Statement of Response Report

Crown Square Phase 2
Strategic Housing
Development

Project Number: **180745b**

Document Title: **Statement of Response Report**

Figure 1: Landscape Character Areas. Extracted from Dwg18375-3-103 Landscape Character Areas

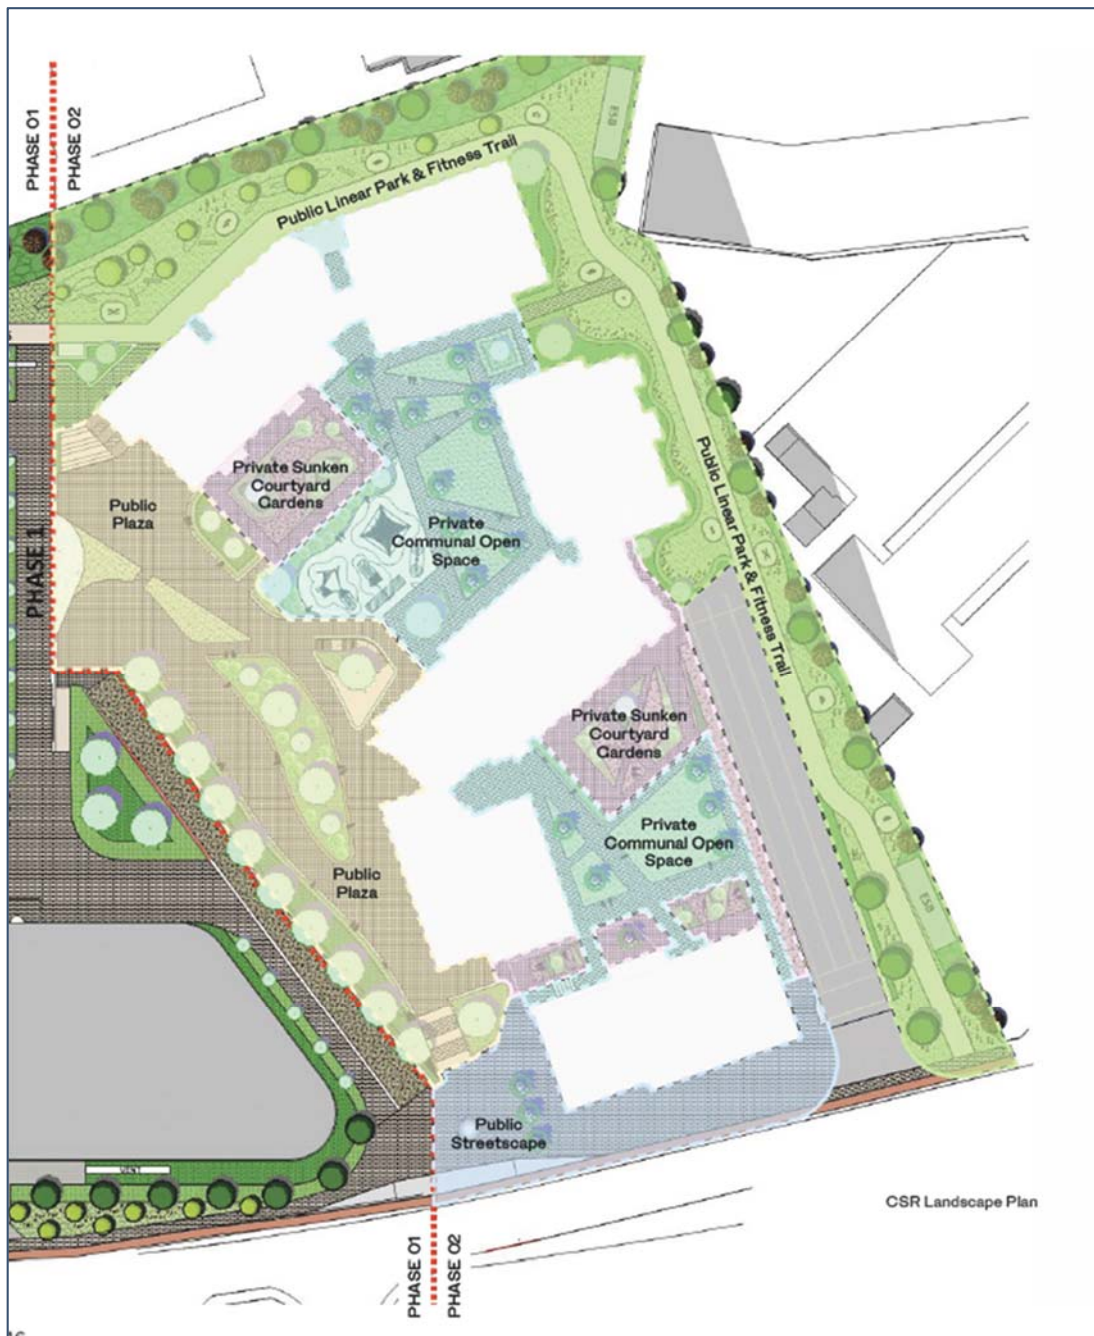
'A report that specifically addresses the proposed materials and finishes of the proposed structures including specific detailing of finishes, balconies and frontages including maintenance of same, the treatment of landscaped areas, pathways, entrances and boundary treatments/s. The treatment/screening of exposed areas of basement ramps and any podiums should also be addressed. Particular regard should be had to the requirement to provide high quality and sustainable finishes which seek to create a distinctive character for the overall development.'

In relation to landscape design, **Dwg 18375-3-103 Landscape Character Areas** demarcates five main character areas within the scheme, three of which offer public access and two being semi-private

The three main public access areas are defined as; ‘Public Streetscape’ presented to the Monivea Road, connecting to the ‘Public Plaza’ at the lower ground level which offers public access through the heart of the development, and finally a ground level ‘Public Linear Park & Fitness Trail’ which offers public access around the scheme’s eastern and northern perimeter ultimately linking with Phase I development and accessing the northwest corner of the scheme.

The semi-private communal residential areas are defined as ‘Private Communal Open Space’ which is accessed at the upper level and ‘Private Sunken Courtyard Gardens’ which are accessed at the lower ground level.

Figure 2: Site Permeability

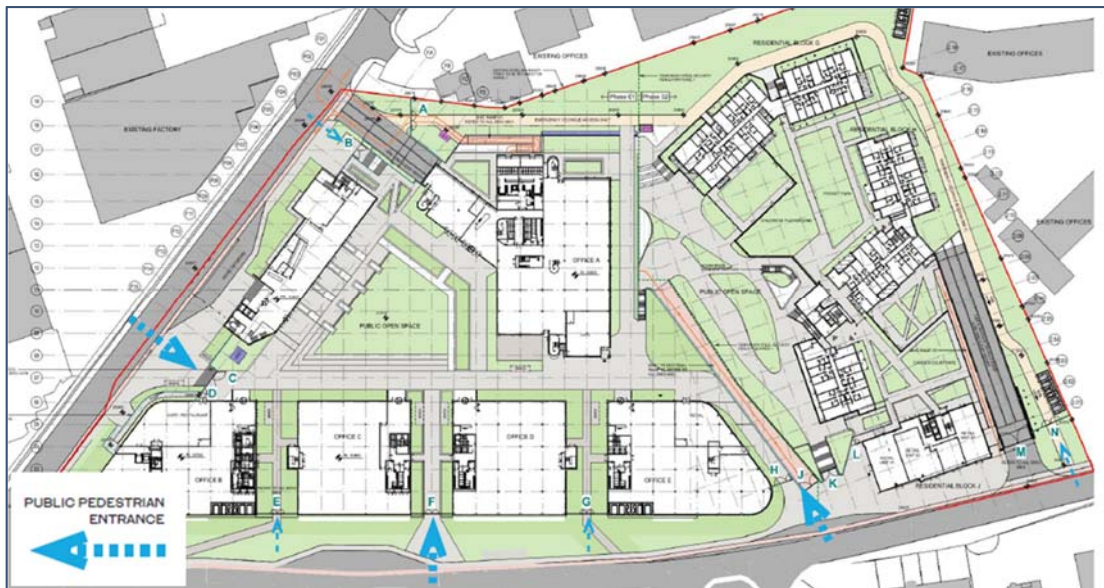
'A public realm and permeability strategy which addresses in particular the accessibility of public open spaces. This should include details in respect of any security measures proposed for the development. Details should also be provided of any potential impact on the open spaces/public realm from the requirement to provide ventilation for car park areas below ground level.'

There are two principal public pedestrian entrances on Monivea Road. The principal entrance is between proposed Phases I and II, with a secondary entrance to Phase I between Office C and Office D. There are two principal public pedestrian entrances on Joyce Road, the principal one between the hotel and Office B with a secondary pedestrian entrance to the north of the hotel beside the vehicular entrance to the basement. There are additional pedestrian and cycle entrances between Offices B/C and D/E as well as pedestrian and cycle entrances to the residential element of Phase II off Monivea Road at either side of the ground floor retail use. See **Figure 2** below.

There are two principal public open spaces for the integrated Phase I/II development. The Phase II public open space is linked to Phase I via a terraced area (now proposed with café/retail use). The Phase I space is central to hotel and Offices A-D. Both are available to site users, residents, visitors and the public. The Phase I space is designated as having ‘event’ use given its size and layout.
